### **AMENDMENTS TO THE DRAWINGS**

## **REMARKS**

FIG. 6.

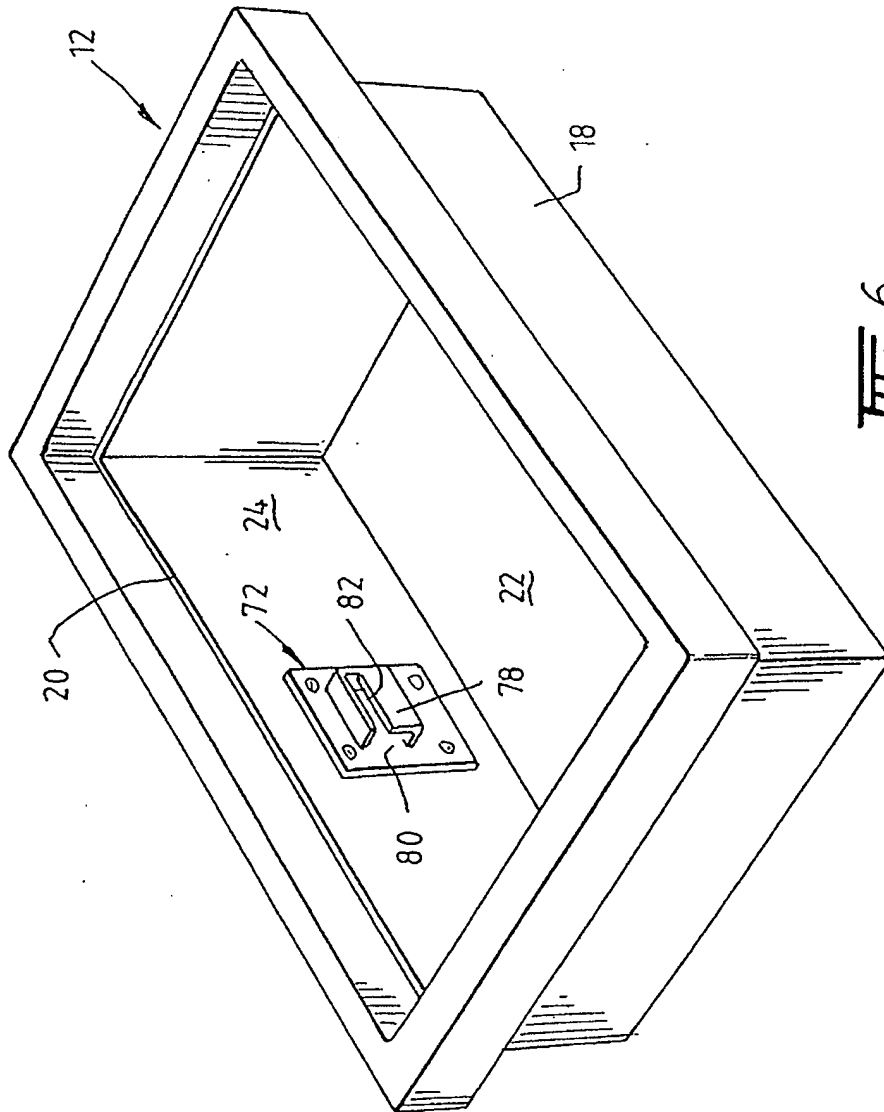
The attached sheet of drawings includes changes to Figure 7. This sheet, which includes Figures 6 and 7, replaces the original sheet including Figures 6 and 7. In Figure 7, previously omitted element identifier 79 has been added.

Element  
Number  
Added
